N	Section	Paragraph	Category	Priority	Comment/Issue Found and Proposed Solution/Clarification, if any
1	2.5 & 3.4	<p>“National scale participants should make efforts to include 100% of forest areas in accounting. However, national scale accounting shall be defined as ≥90% of all areas in the country qualifying as forest under the national forest definition as described in Section 3.4. Areas excluded must be isolated, patchy and historically not subject to deforestation rates of less than half of the national rate.”</p>	Clarity	3. Very High	<p>Comment: The threshold of ≥90% for national scale accounting, while requiring efforts to reach 100%, raises questions about its practical application. For example, if a country has 90% of its forests in a specific region (e.g., Peru, where forests are concentrated in certain provinces), does accounting for only that region qualify as national accounting, potentially excluding other provinces? Additionally, if a country’s forest area exceeds 90% in a defined region, is monitoring 100% of the territory mandatory? The relationship between the 90% requirement and the administrative levels could be made clearer as it is unclear if there is an align

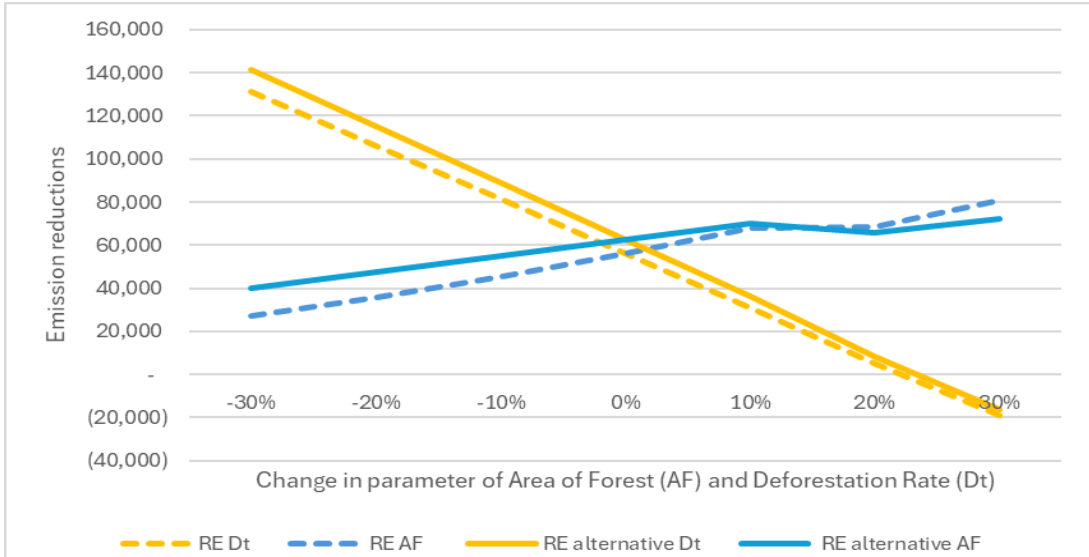
11	5.2.2	Equation 5	Technical/ Methodological	3. Very High	<p>Comment: Equation 5: The use of the parameter ‘carbon stocks’ is misleading as it gives the reader the understanding that you are paying for carbon stocks or similar. In reality, this equation establishes the maximum amount of emissions that it is allowed to increase. The equation is inspired from the equation used in the FCPF. Let us clarify that under the FCPF, carbon stocks are in reality estimated by multiplying the forest area in the program by the emission factor used for forests, so in essence, this means that the FCPF allows a maximum adjustment in historical emissions equivalent to an increase in 0.1% in the deforestation rate, i.e. if the country has a deforestation rate in the reference period of 0.2%, then the maximum adjustment would be of 0.1%, or in this case a 50% increase in deforestation. I think that presenting the equation as 'allowable increase in emissions' rather than carbon stocks is more accurate and would serve readers to understand better what it actually means. Moreover, the area of forest does not say much about the historical forest cover and expected deforestation trends,... for instance, countries like Central African Republic have large swaths of land of natural savannah and grasslands, but they do not qualify because they do not reach the minimum FC despite being actually and HFLD country. ROC and DRC have also large areas of natural savannahs that never contained forest.</p> <p>Suggestion: We would suggest the following notation which is easier to understand and does not differ that much from the previous equation. $HFLD\ CL = CL + \text{Allowable adjustment} = CL + \text{Emissions equivalent to } 0.05\% \text{ deforestation rate} \times \text{conservativeness factor} = CL + (0.05\% \times AF \times EF) \times (1 - DR_t)$. In the below graph we show the sensitivity analysis for variables Area of Forest (AF) and Deforestation Rate (Dt), which shows that the outcomes are similar, and marginally less conservative. Moreover, it is less sensitive to increases in forest area, which makes more sense. The proposed equation is also easier to understand.</p>
